AMDT. TO OL/CHANGE TO TECH SPEC CONSISTING OF
APPLICATION SEEKING TO AMEND SEC. 3.1 7d IN
APPENDIX A.

NINE MILE POINT #1

APPLICATION FOR AMENDMENT

Proposed Changes To Facility Operating License

Figure 3.1:7.f

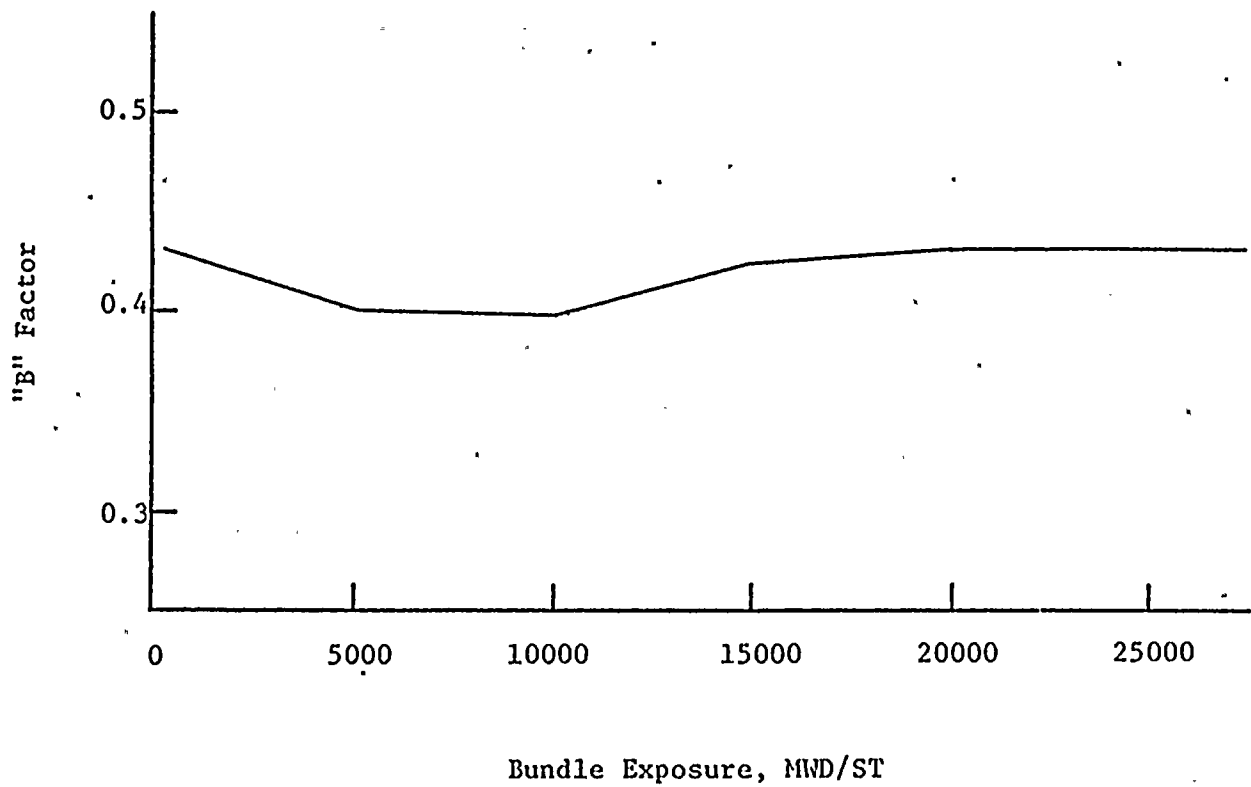
The present "B" factor calculations were based on constant dryout times for each of the 7 x 7 and 8 x 8 fuel types. Subsequent evaluations by General Electric, however, revealed that dryout times are exposure dependent. The re-calculated "B" factors, shown on pages 64c - 64e, reflect these variable dryout times.

It should be noted that the proposed limits are generally more restrictive for Fuel Types 1 and 3, and generally less restrictive for Types 2, 4, 5 and 6. Since Fuel Type 4 is currently limiting power output, the net effect of this change would permit a slight increase in power from the plant.
